### Historic Architectural Review Commission Staff Report for Item 2

**Application Number:** 18-2459

**Address:** #1 Whitehead Street

Installation of aluminum impact doors with historic imagery and reconfiguration of front entry of the Key West Aquarium. New fountain at front.

## REVISED DESIGN

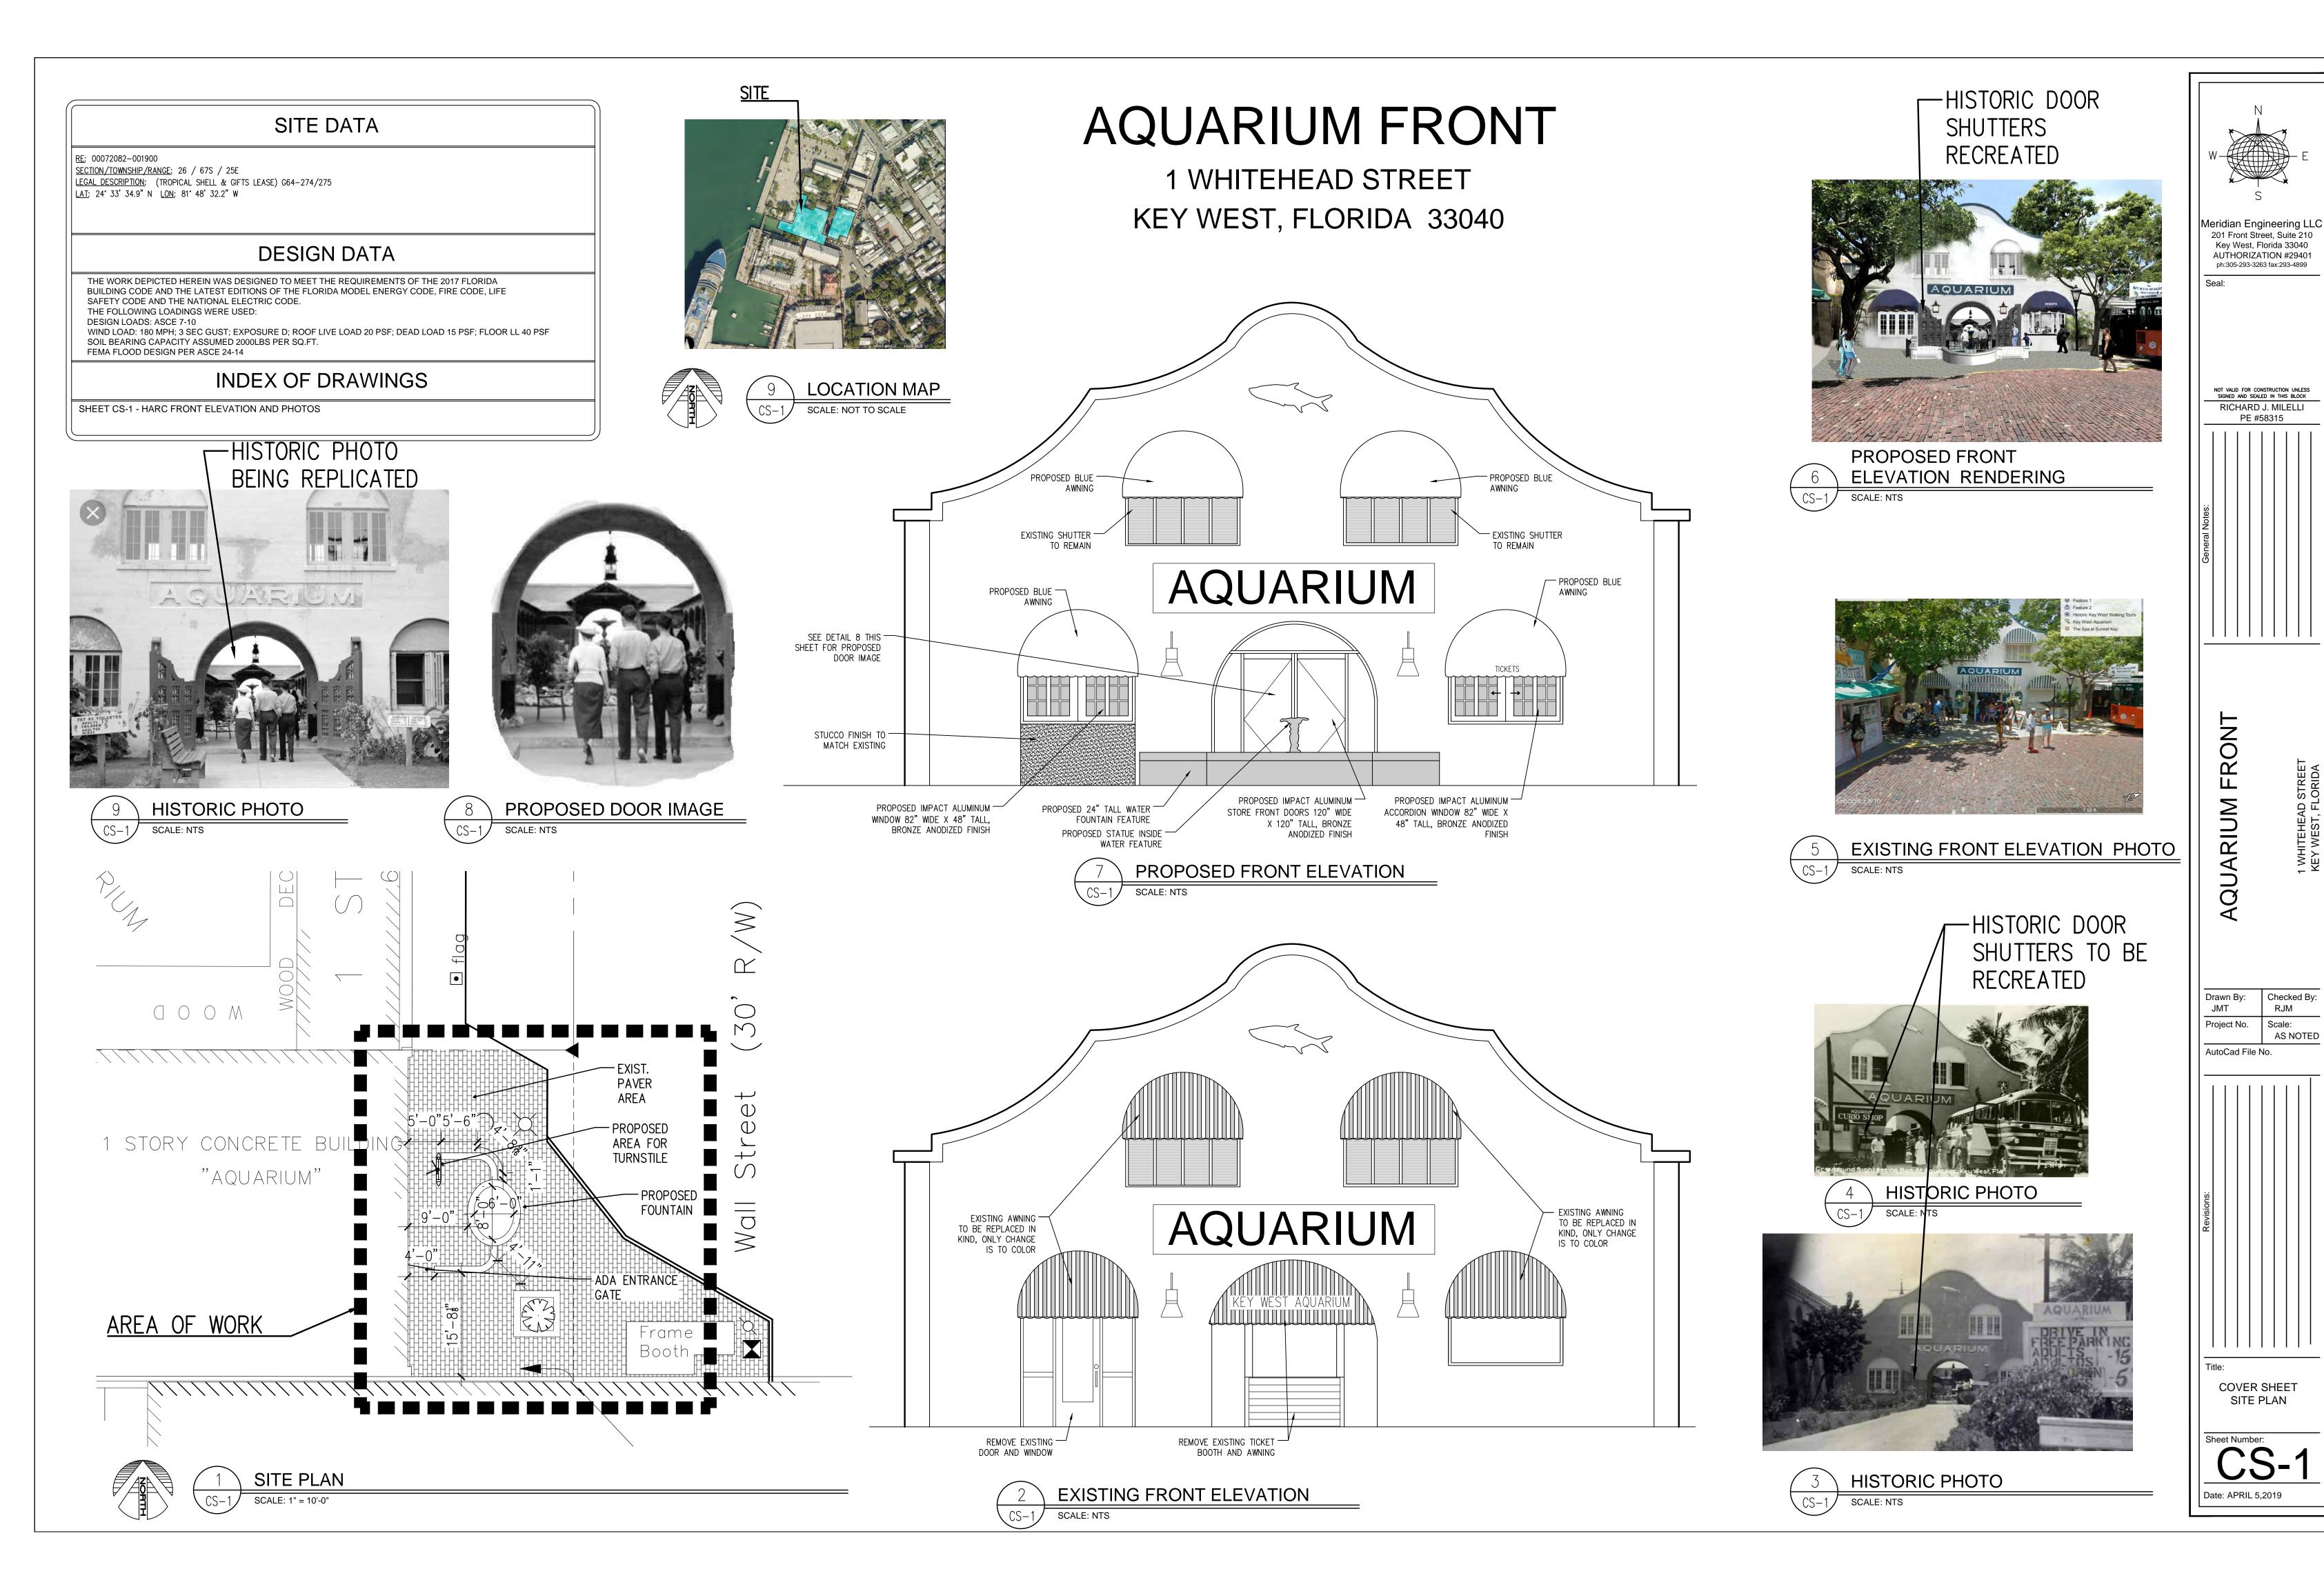
A new fountain will be installed in front of the aquarium. The fountain will be 24 inches, but the statue will be taller. The number is not specified on the plans. The site plan indicates that there is a proposed area for a turnstile, but no turnstile is depicted on the elevations.

aquarium originally had wood casement windows that were painted white. The proposed bronze aluminum windows are inconsistent with the guidelines for windows and Secretary of the Interior's Standards for Rehabilitation.

While historically, the aquarium had an open entrance, over time the aquarium was converted into an enclosed space as an open roof aquarium was not particularly successful for the management of fish and other wildlife. Therefore, with the removal of the booth, a new enclosed entryway will need to be installed. Staff finds that the new entryway doors are appropriate to be bronze aluminum because the dark color will reduce the visual impact the new doors will have on the building. The proposed infill should not be visually intrusive, and a darker color will reduce the impact.

In order to control visitors from entering the building without a ticket, the applicant is proposing a large fountain area in front of the building. The guidelines for accessory structures are clear that, "no accessory structure may be built in the front yard of a structure in the historic district" (Page 40, Guideline 2). Also "accessory structures shall be compatible with the principal structure on the lot in materials, detailing, color, style design, height, scale and massing" (Page 40, Guideline 1). There was never a fountain in the front of this structure. Fountains on the exterior of buildings are not traditional to Key West. The proposed accessory structure is not compatible with the building or the surrounding context.

While staff applauds the applicant for proposing to remove the booth and awning that obscure the front of the historic building and renovating the front façade with new windows. Staff finds that the material and color of the windows to be inconsistent with the guidelines. The windows should be wood and white, as is well documented in historic photographs.

The other aspect of the application that staff finds to be inconsistent with the guidelines is the installation of a fountain in the front of a contributing building. The applicant is proposing to introduce a new feature that is not historically accurate or traditional to Key West's historic district. There are other ways to deter visitors from entering the building without ticket that won't be so permanent or won't have such a large impact on the building and its environment (such as stanchions with retractable belts or velour ropes). The plans mention a turnstile, but that is not included on the elevations, so staff does not know what impact that will have visually on the building.
